Davis-BesseNPEm Resource

Regarding: Docket No. 50-346; NRC-2010-0298

Davis Besse re-licensing community hearing
St. Mark's Episcopal Church, Toledo, OH
December 18, 2010

Errors in the First Energy Environmental Report (Appendix E):

Average Daily Solar Radiation 1961-1990

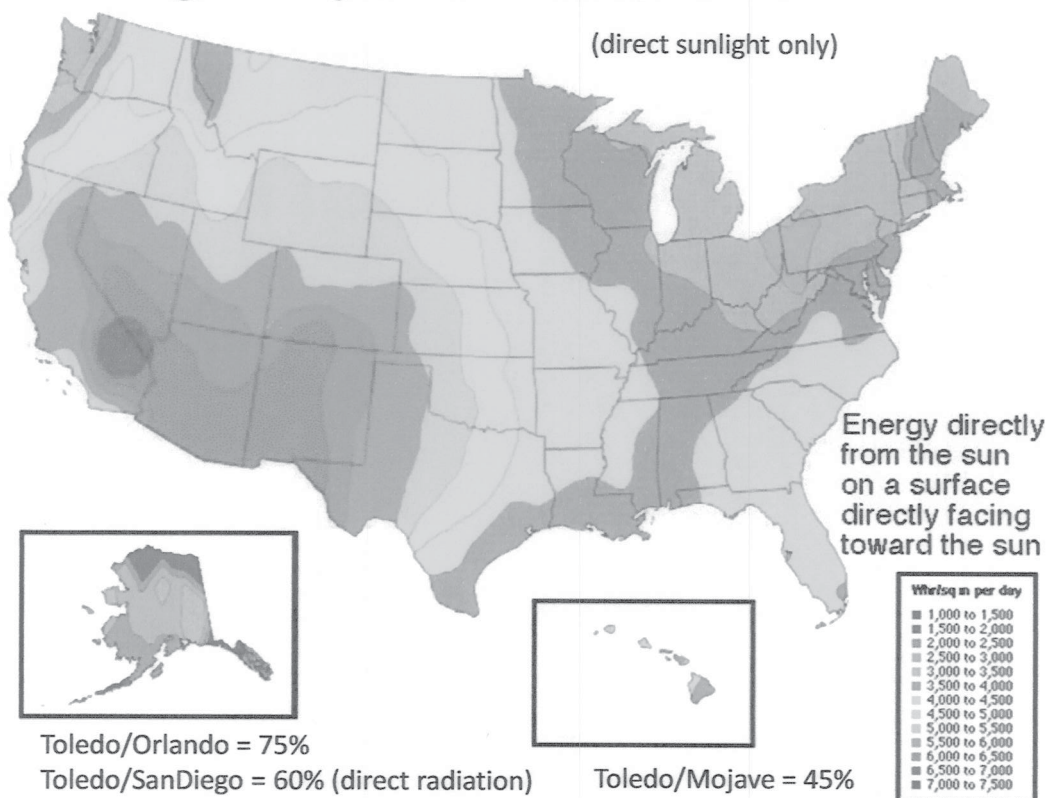
- must consider full-sky insolation, not just direct solar
- must use current costs and cost projections for PV, not data from 1998!

Figure Volatility vs Maximum Output of several hypothetical combination systems of solar and wind

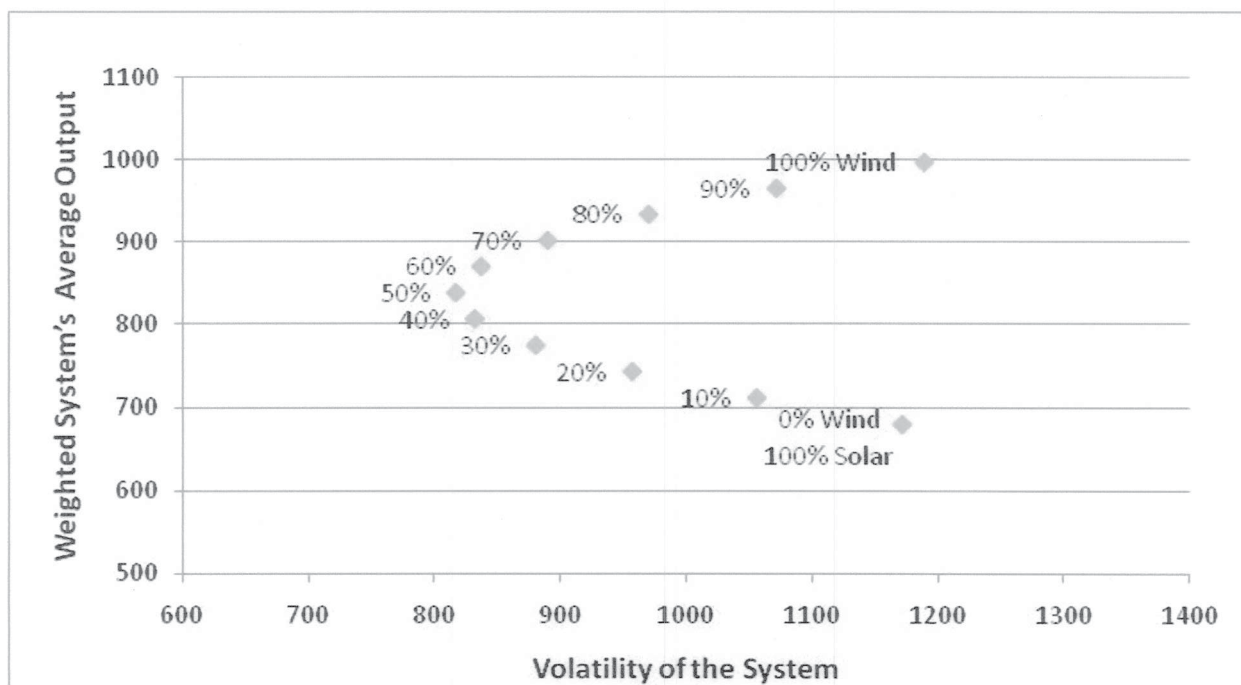
In section 7.2.2.2 of the Davis Besse Nuclear Power Station License Renewal Application, Environmental Report, First Energy dismisses all forms of renewable energy as a replacement for the 910MW from Davis Besse. Two types that are largely researched and widely used today are solar and wind power, both of which First Energy does not feel are satisfactory forms of energy production to be applied to the grid. The reasons they state are intermittency of power production, large land requirements for installation of either type, the low wind and sunlight irradiance in Ohio compared to other states, associated aesthetic impacts and the high costs per kilowatt-hour of capacity. Low wind speeds and irradiance in the area and costs are discussed in the notes by Dr. Alvin Compaan.

It is true that solar panels will only produce power during the day when the sun is shining, and that both wind speeds and solar irradiance change throughout the day and year; however, by looking at systems that are already in place in the area and around the world, we will be able to gain a better understanding of how to use these different types of renewable energy. This study specifically shows the case for Northwest Ohio and how it can in fact, be applied to the grid.
